UNITED STATES OF AMERICA
NUCLEAR REGULATORY COMMISSION

(License Renewal for the Oyster Creek
Nuclear Generating Station))

Docket No. 50-0219-LR

**CITIZENS' INITIAL STATEMENT REGARDING RELICENSING OF OYSTER
CREEK NUCLEAR GENERATING STATION**

Figure 1

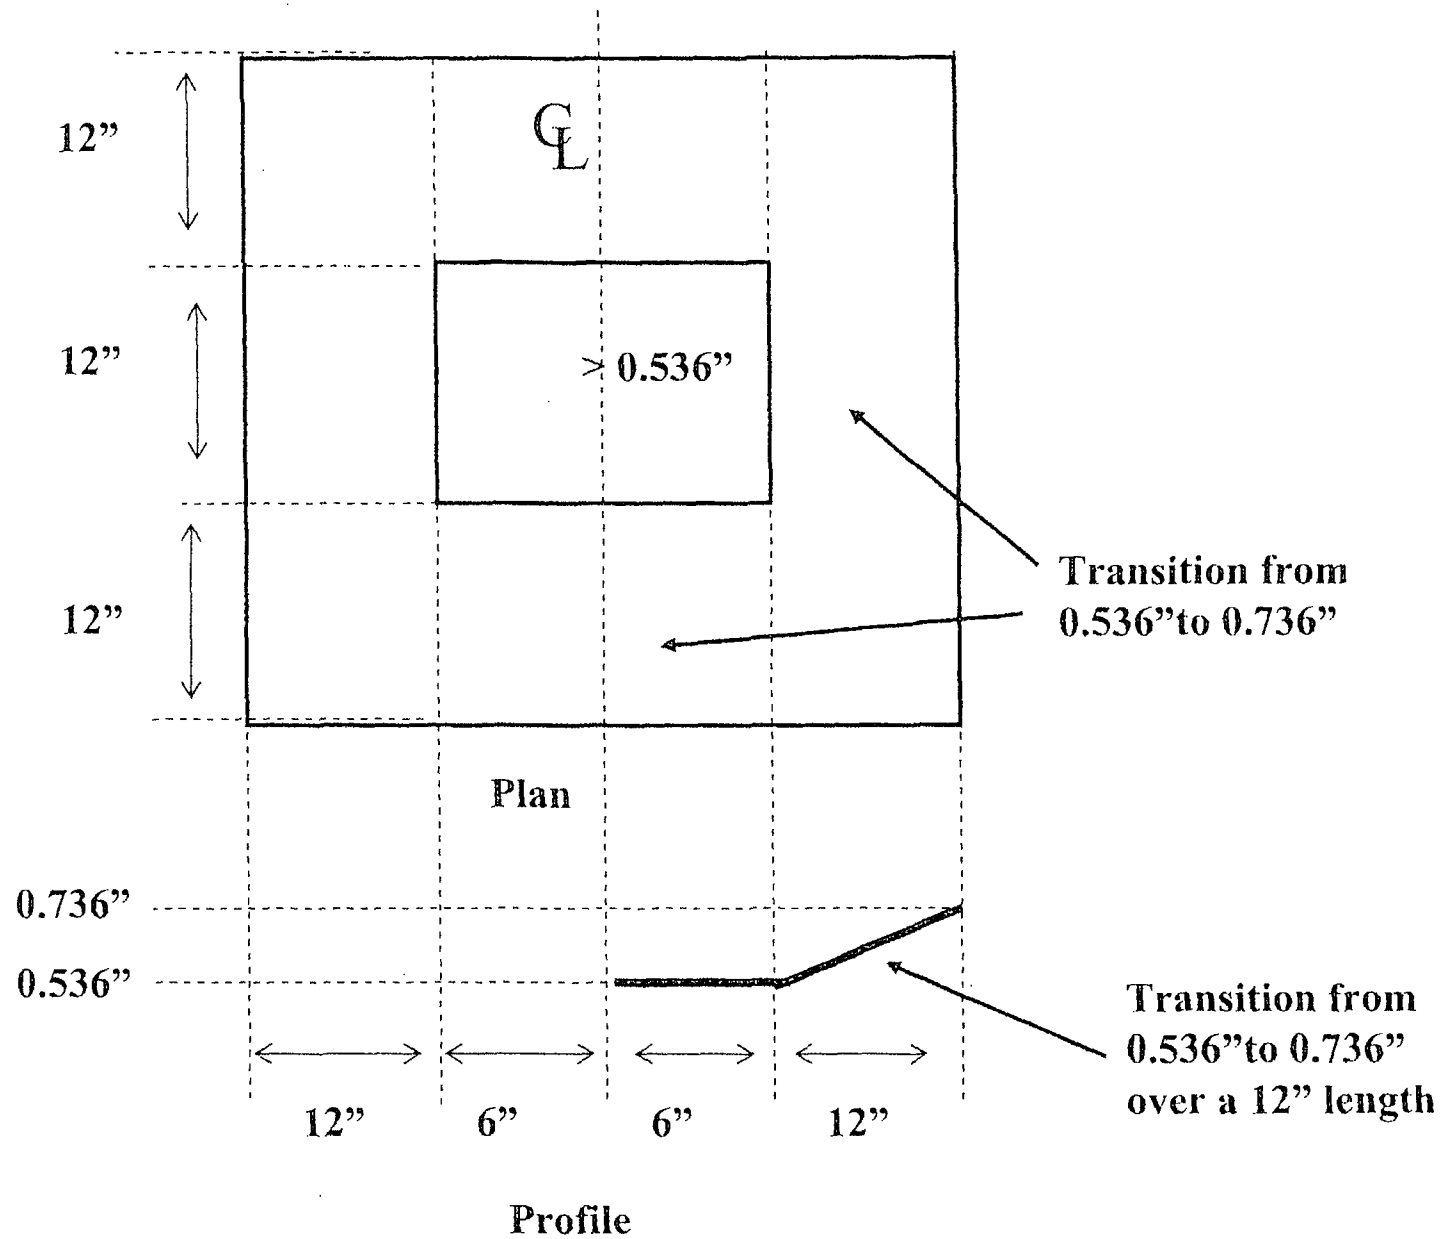
area criterion includes a one-foot *transition area* to 0.736" on all four sides of the 0.536" area, such that the total allowable contiguous area with thickness below 0.736 is *nine square feet*. This is clearly shown on Figure 1 which I created, and which is based on the GE Nuclear report that was attached to the AmerGen submittal to the ACRS on December 8, 2006, as Reference 22.

Figure 2

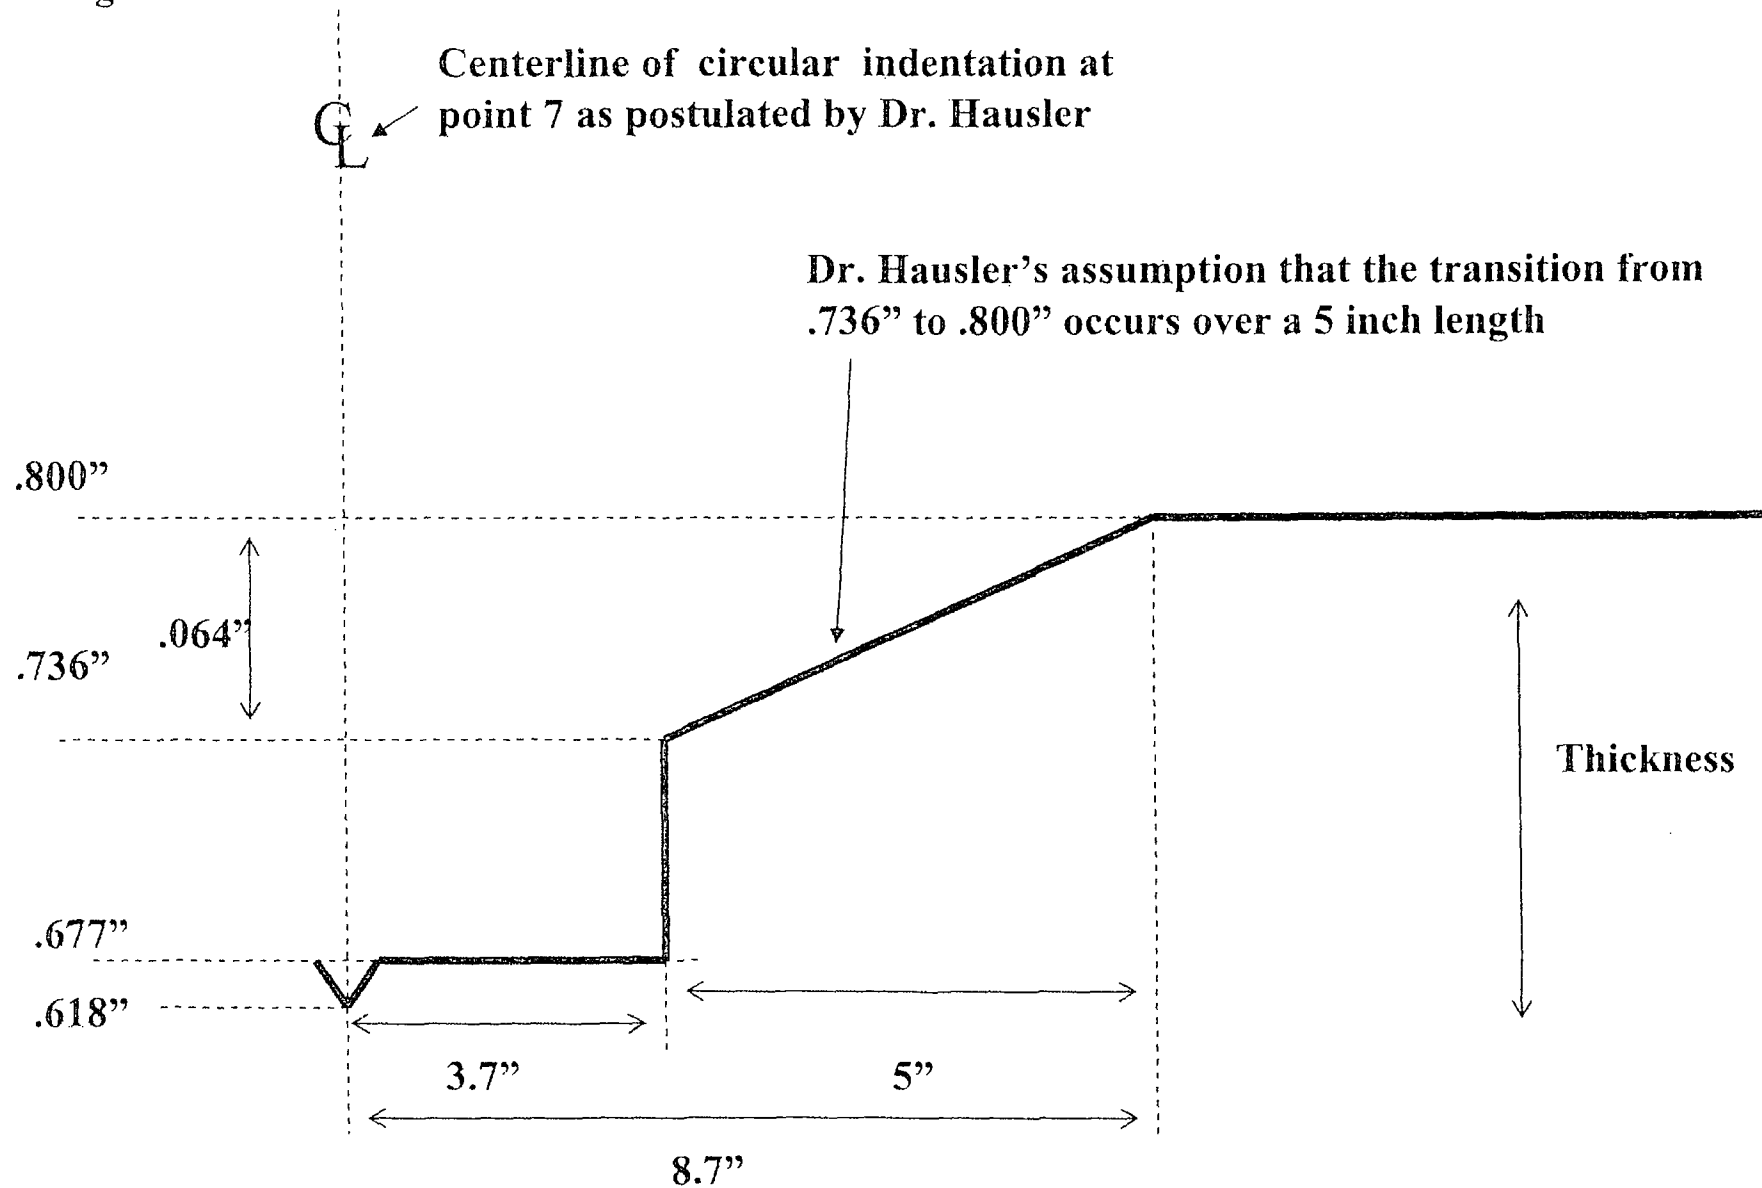
22. Dr. Hausler's misunderstanding seems to stem from his belief that the local area acceptance criterion is configured with an abrupt step-change (like a cliff) on all sides of the one square foot area that averages 0.536", such that the thickness increases to 0.736" with no transition. See Figure 2.

30. On page 7 of his June 23, 2006 memorandum, Dr. Hausler states that the total area less than 0.736" at "point 7", referring to the area which averages 0.677", is 0.3 square feet. Although the 1992 Oyster Creek reports describe this area as a 6" by 6" square area, Dr. Hausler elects to convert this area into a circular area. The corresponding radius of the circular area, which is 0.3 feet square, is 3.7 inches. I have created Figure 2 to show a profile representing these measurements.

Dr. Hausler states on page 7 of his June 23, 2006 memorandum that "this area is very sensitive to corrosion because in a length of around 5 inches, the thickness changed from around 0.736 inches to 0.800 inches. Assuming the edge of the hole is a straight line, this means that a change of 0.064 inches in depth occurs over about 5 inches in length." Dr. Hausler assumes that the transition from the thinner area less than 0.736" to areas that are 0.800" or thicker is 5" long (radially). As I said, this assumption is not supported by the data. However, if you construct a model of a hypothetical indentation as described in this unsupported assumption using the 5" transition zone and the corresponding inner radius of the 3.7", the total radius of the model is 8.7" or 17.4" in diameter. Figure 2 also shows this configuration.

Figure 3

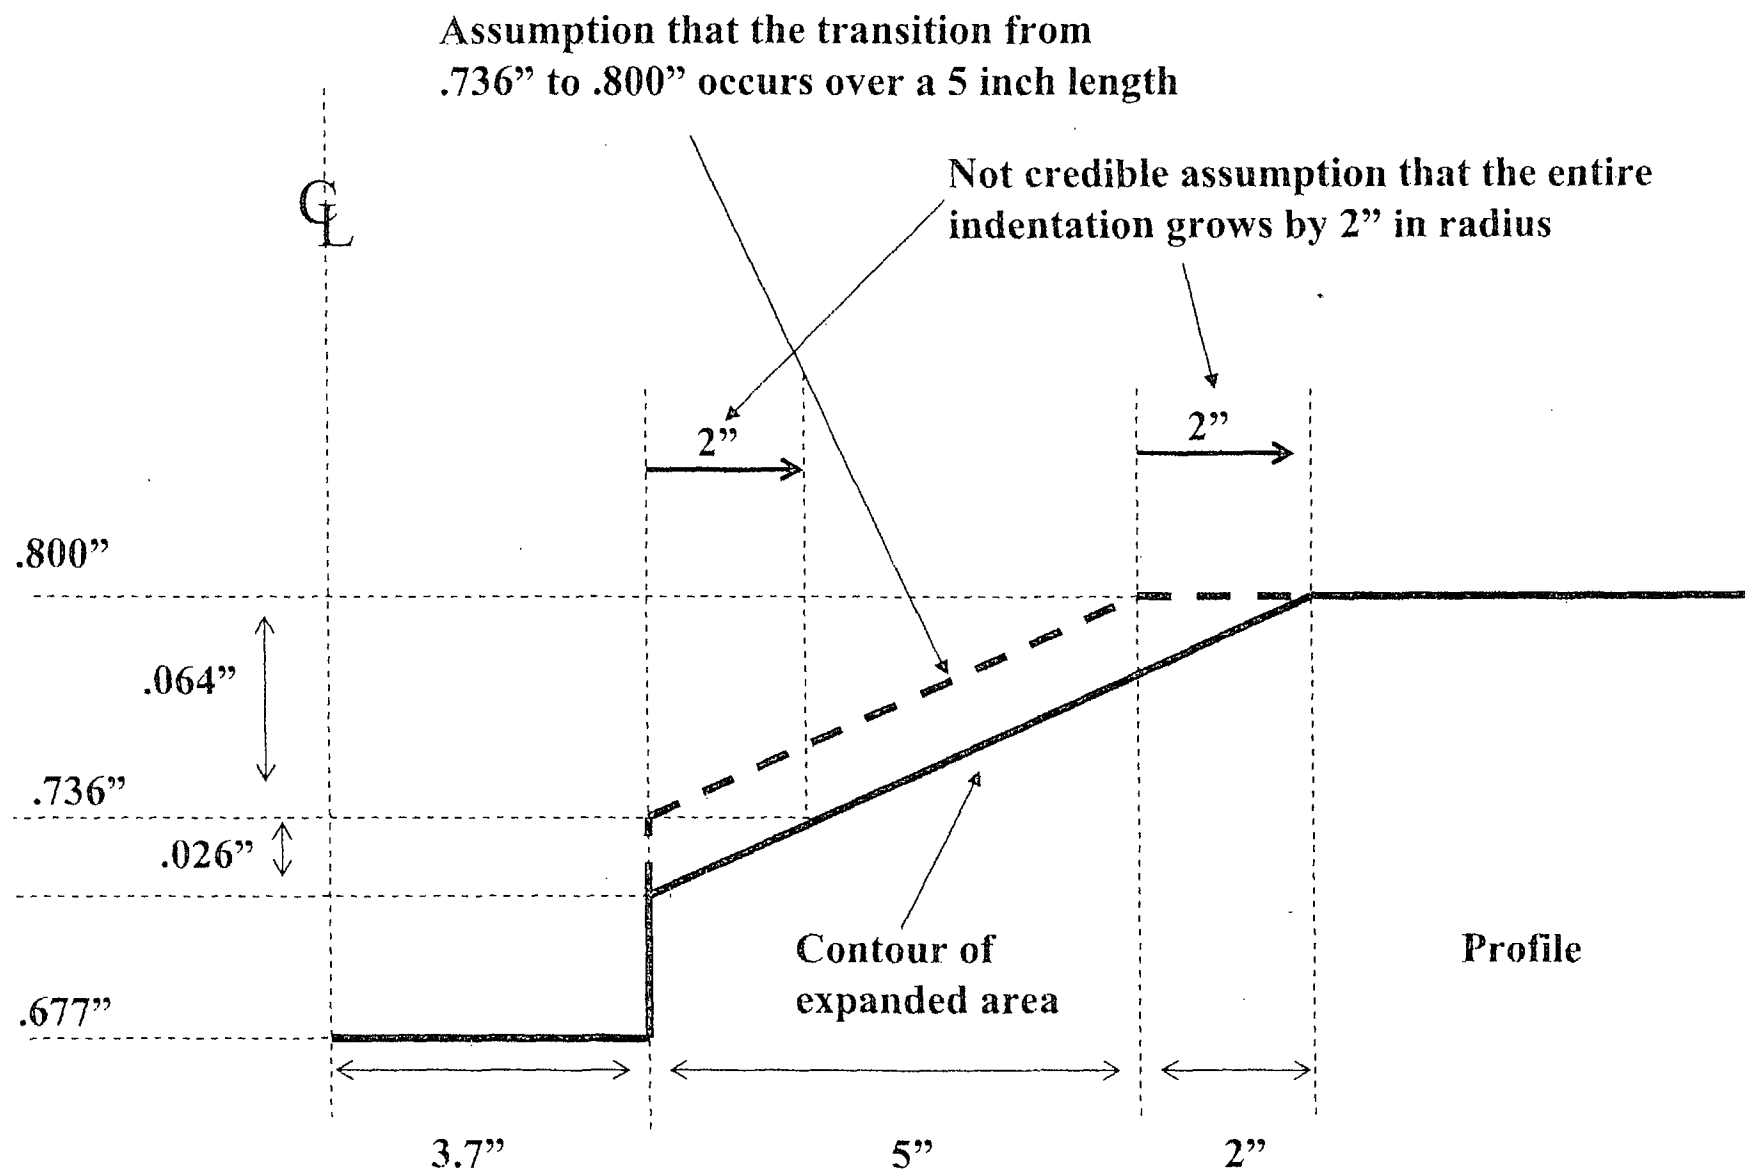
Regardless, by expanding the radius of the indentation by 2", the diameter of the indentation would increase by 4", for a total diameter of 21.7" (this is larger than Dr. Hausler's memo which mentions 17.4" diameter). I have created Figure 3 to show the increase of the radius of the hypothetical indentation by 2".

Figure 4

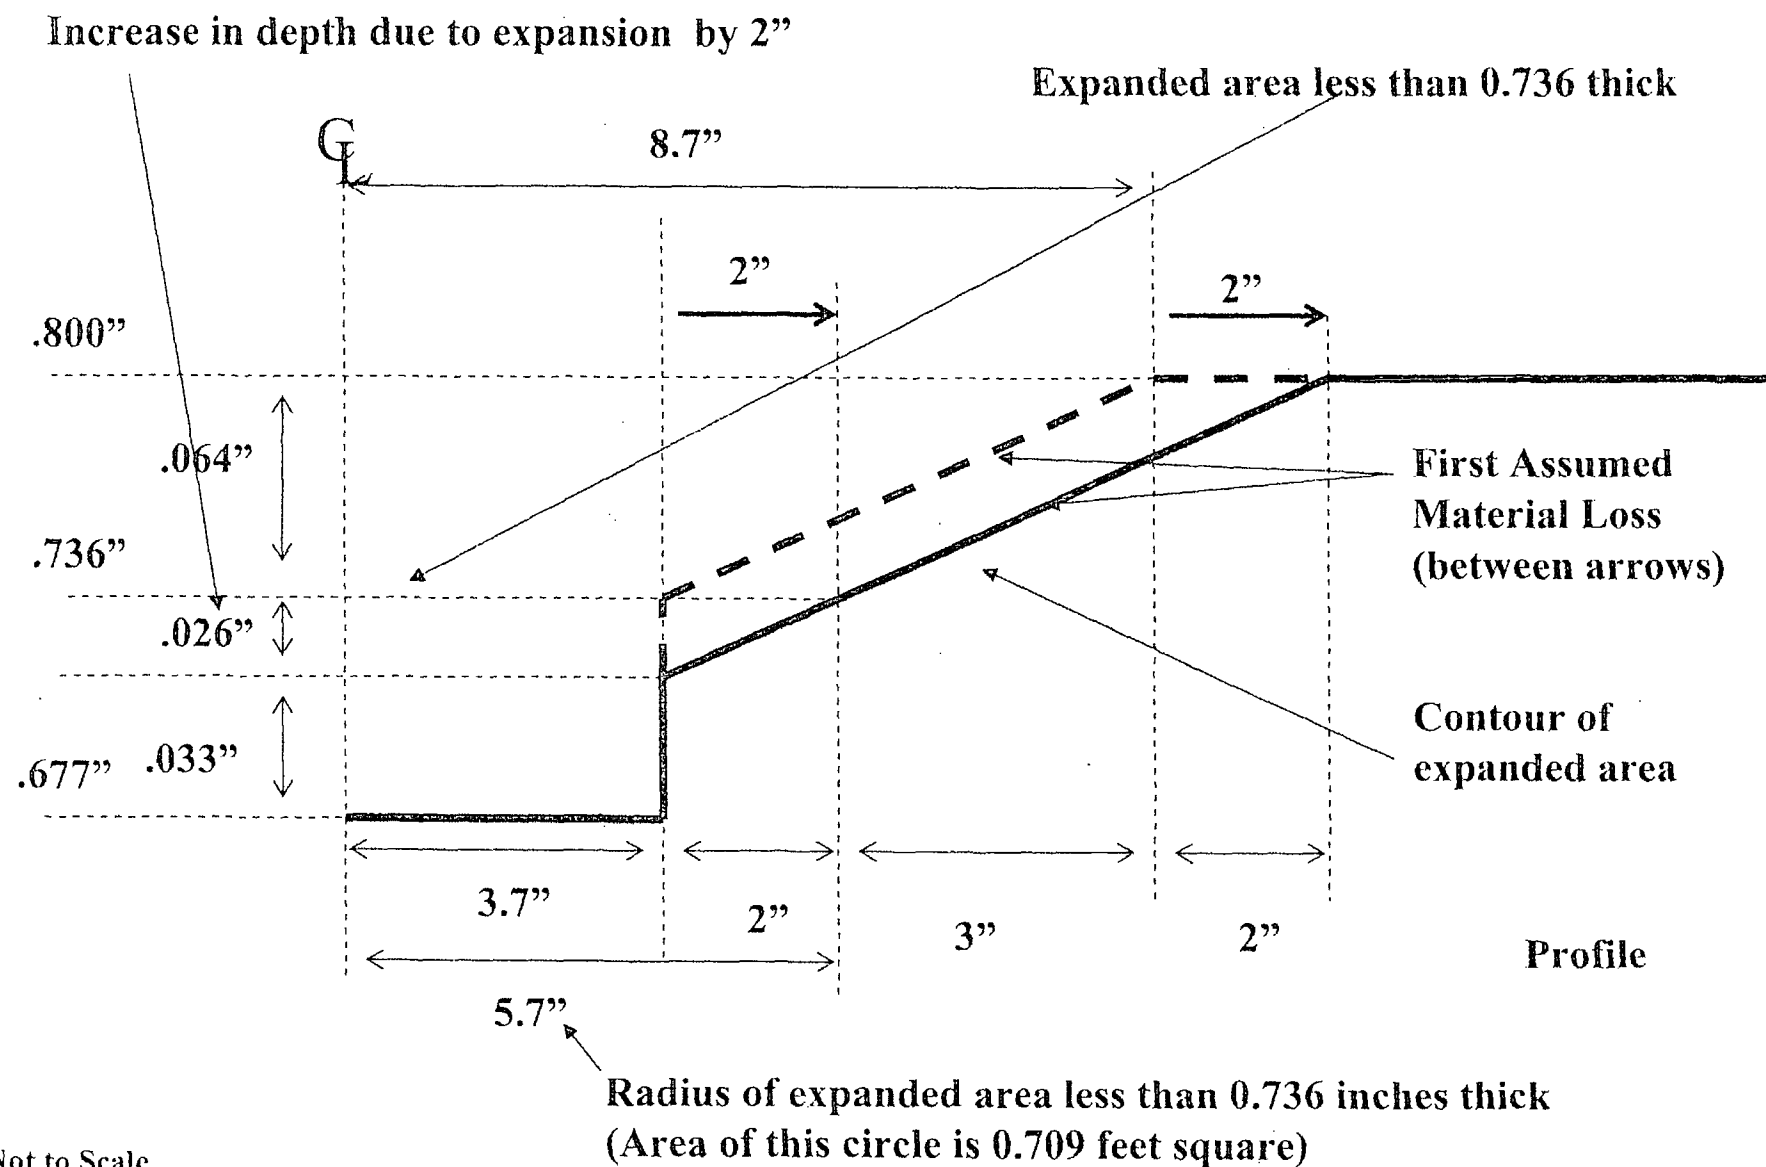
34. First, this conclusion is proved false by Dr. Hausler's own model. The radius of the expanded area less than 0.736" (shown on Figure 4) is 5.7". Simply calculating the area of a 5.7" radius circle results in 0.709 square feet. This value is significantly less than the 1.6 square foot value that Dr. Hausler offers.

Figure 6

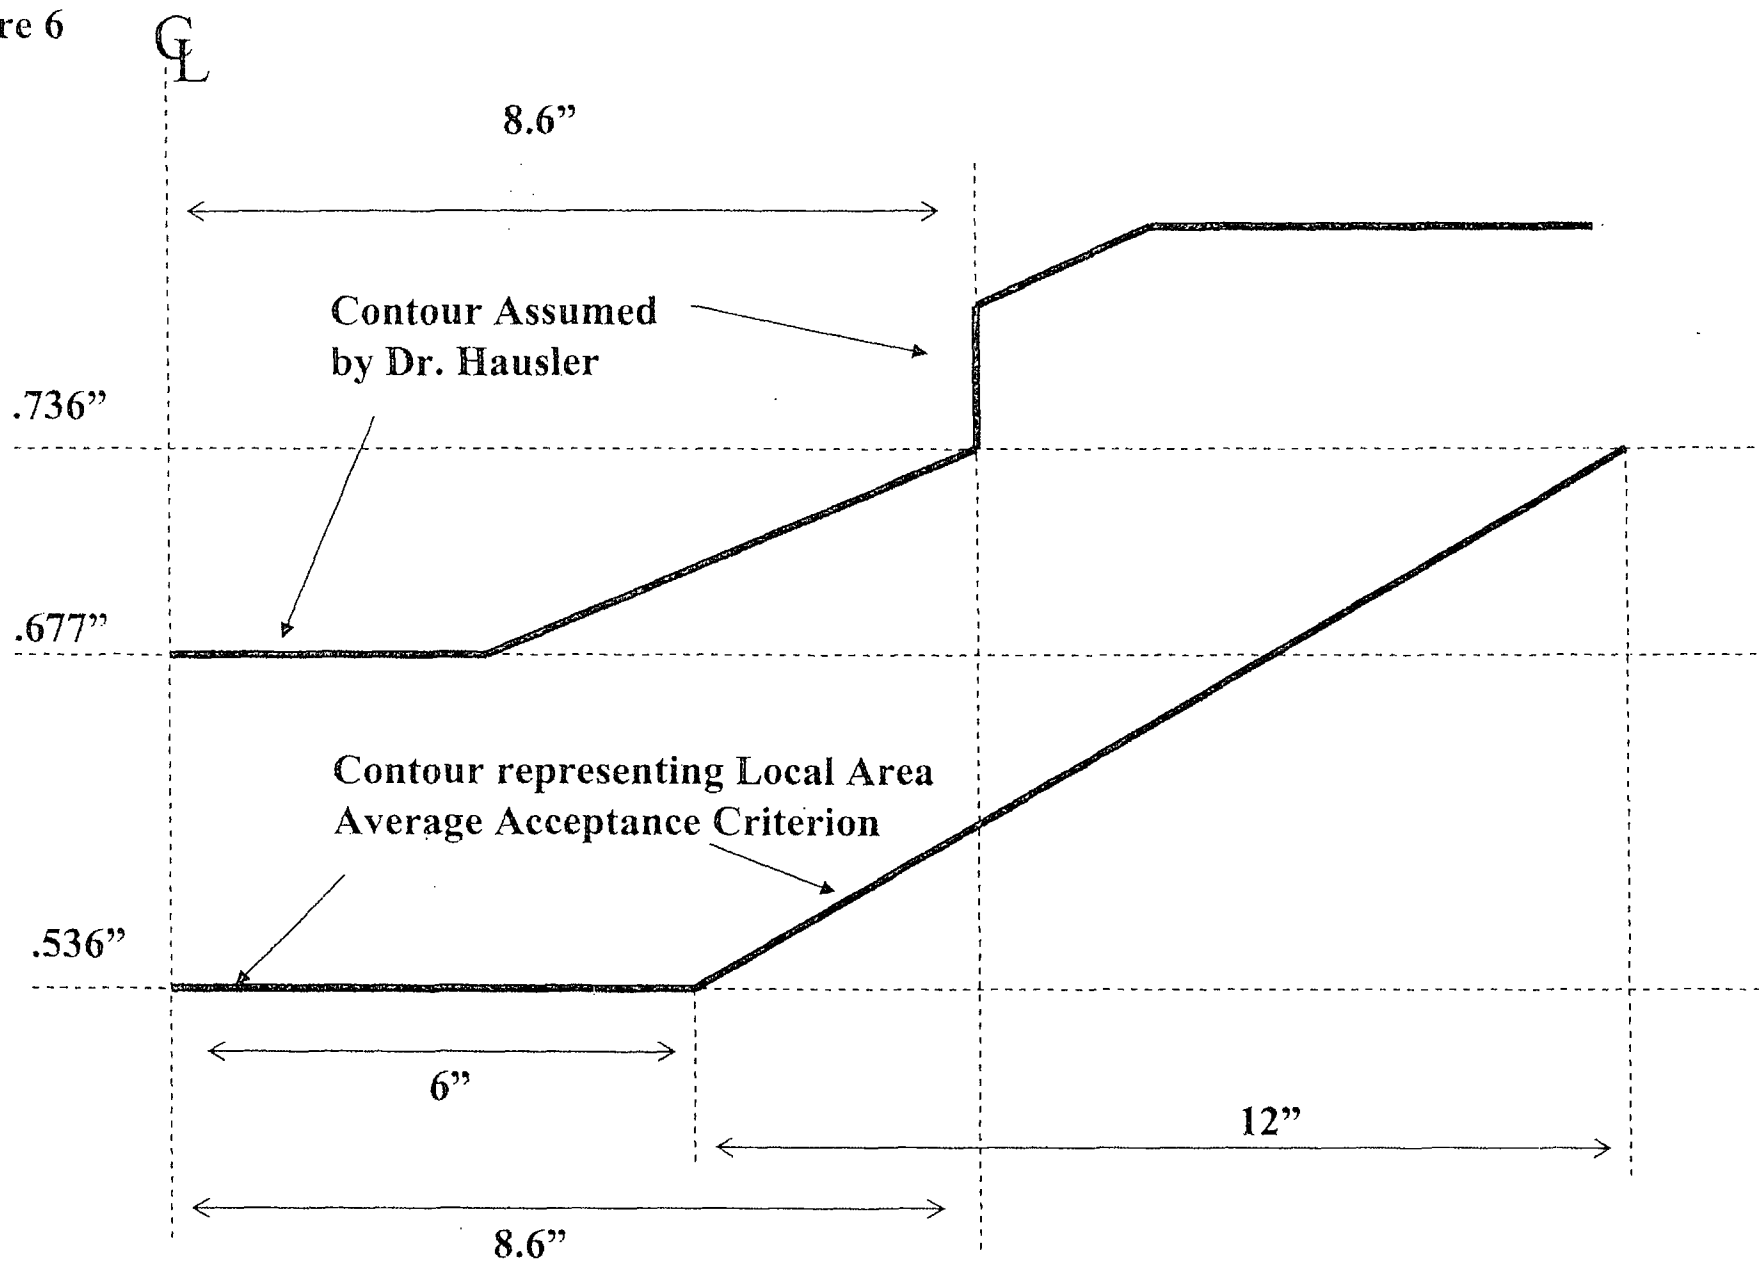
36. Finally, as I state above, Dr. Hausler then misinterprets the local area acceptance criterion by assuming that an area of one square foot that is thinner than 0.736" exceeds that criterion. He is wrong and I have created Figure 6 to show how the additional corrosion that Dr. Hausler postulates would not exceed the local area thickness criterion. In Figure 6, I have reproduced the acceptance criteria profile from Figure 1, and overlaid Dr. Hausler's assumed contour from Figure 5. The new Figure clearly shows that the acceptance criterion is not exceeded.
